Service Bulletin

Release of NX 2.0.8900 / 3.0.8900 SU2 for installed DX-D 100 / DX-D 100 Wireless systems

- This document informs the field about the introduction of the new NX 2.0.8900 / 3.0.8900 SU2 for the installed base of the DX-D 100 / DX-D 100 Wireless.
- It also contains the solution for the listed Problem Record.

Figure 1

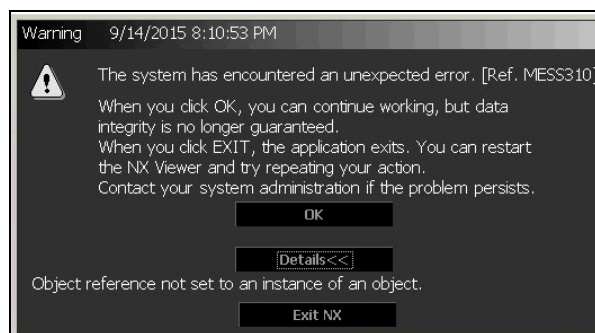
PRB0049311: MESS310 at systems with touch screen when leaving Viewing and Editing screen*Symptom*

Error MESS310 when leaving the Viewing and Editing screen. Following preconditions must be fulfilled so that the symptom appears:

- System has NX 2.0.8900 / 3.0.8900 (SU1) installed and is configured for touch mode (for DX-D 100 touch mode is always activated).
- Collimation Tool is deactivated (activated by default).

Cause Software bug introduced in NX 2.0.8900 / 3.0.8900 as part of the introduction of Touch Mode buttons in the Viewing and Editing environment: When leaving the Viewing and Editing environment, the software wants to close the Collimation Tool combo box. If this is not available MESS310 is shown.

Figure 2

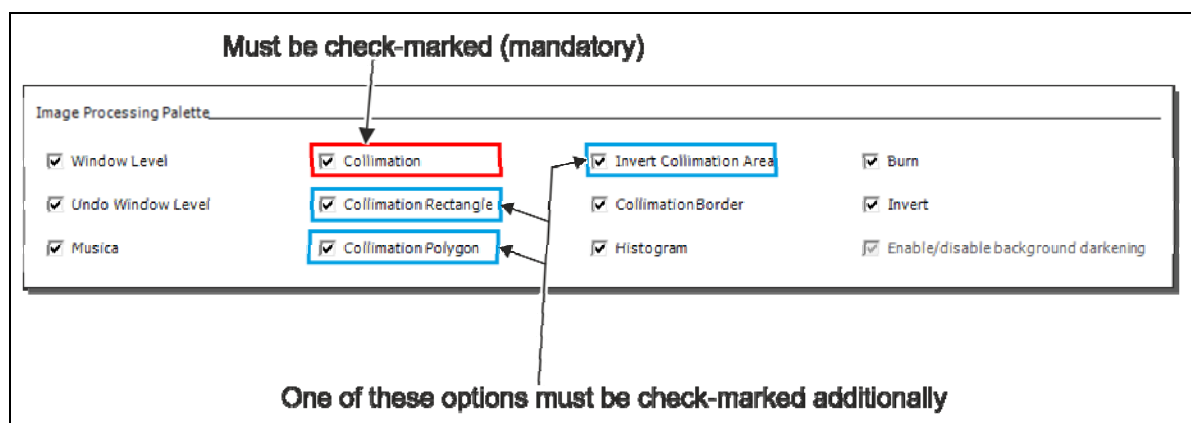
Solution Workaround:
In the **NX Configuration Tool > User Interface > Editing Settings > Configure Tools & Annotations > Image Processing Palette** the **Collimation** option must be check-marked
PLUS at least one of its additional options [**Collimation Rectangle**, **Collimation Polygon**, **Invert Collimation Area**] must be check-marked.
Note that CollimationBorder is not part of the Collimation Tool combo box.
A software solution is planned for the next NX software release.
